Engineering Evaluation Cost Analysis Work Plan

68th Street Landfill Site Rosedale, Maryland

RESPONSE TO COMMENTS

Responses to comments issued by the U.S. Environmental Protection Agency (USEPA)-Region III and the Maryland Department of the Environment (MDE) relative to the Engineering Evaluation Cost Analysis Work Plan (EE/CA) are presented herein. Each comment is presented verbatim in *italics* with a direct response to the comment immediately below. The responses have been incorporated in the revised EE/CA as denoted herein.

FIGURE 3
EE/CA Characterization Flow Diagram
68th Street Landfill Site
Rosedale, Maryland

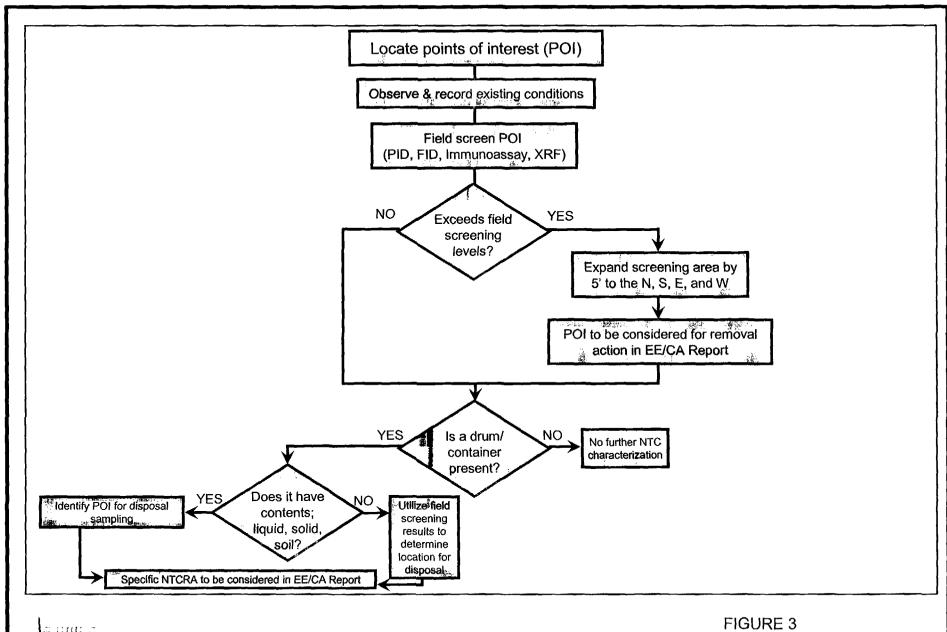
6. Figure 3 Modify the Characterization Flow diagram to describe the actions that will be taken if Action Levels are exceeded.

The Characterization Flow diagram has been revised. If the results from the initial field screening location exceed the established, now lower screening levels, additional field screening will be conducted in an expanded area that could reasonably have been affected by a

contained release (reference Section 3.1.2). Specific removal actions for areas that exceed these screening levels will be identified and addressed in the EE/CA Report.
